UNITED STATES PATENT AND TRADEMARK OFFICE

APPLICATION NO.	FILING DATE	FIRST NAMED INVENTOR	ATTORNEY DOCKET NO.	CONFIRMATION NO.
10/618,200	07/10/2003	Ying-Che Huang	03171-URS	4173

Office Action Summary	Application No. 10/618,200	Applicant(s) HUANG ET AL.	
	Examiner William H. Rodriguez	Art Unit 3746

DETAILED ACTION

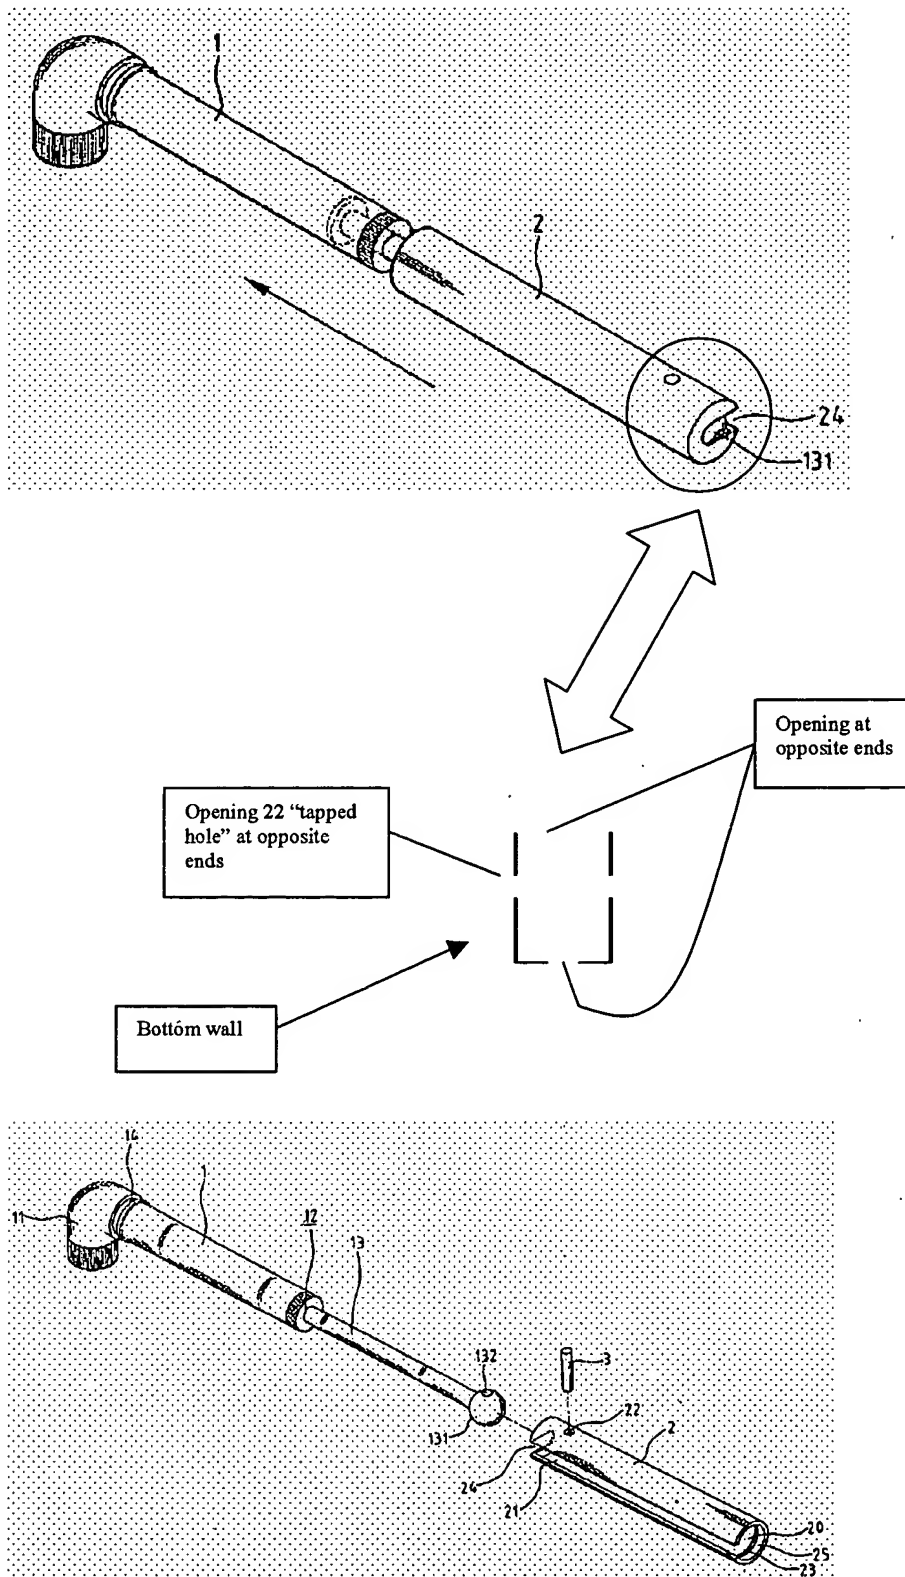
2. **Figure 5 should be designated by a legend such as --Prior Art--** because only that which is old is illustrated. See MPEP § 608.02(g). Corrected drawings in compliance with 37 CFR 1.121(d) are required in reply to the Office action to avoid abandonment of the application. The replacement sheet(s) should be labeled “Replacement Sheet” in the page header (as per 37 CFR 1.84(c)) so as not to obstruct any portion of the drawing figures. If the changes are not accepted by the examiner, the applicant will be notified and informed of any required corrective action in the next Office action. The objection to the drawings will not be held in abeyance.

4. Claim 1 is rejected under 35 U.S.C. 102(b) as being anticipated by **Prior Art Figure 5**.

With respect to claim 1, **Prior Art Figure 5** teaches a collapsible handgrip for inflator, comprising: an air cylinder A having a shaft B connected with a piston (not shown but inherent), in which a stud (not shown but inherent*) arranged at one end of the shaft extends out of the

cylinder; and a handgrip D which is a hollow tubular body having a bottom wall and an opening at the opposite end, in which a tapped hole C is formed in the bottom wall for locking the stud and storing the cylinder in the handgrip, and the stud is also meant to be locked to the tapped hole through the bottom wall of the handgrip for extending the length of the shaft. See particularly **Figure 5** above.
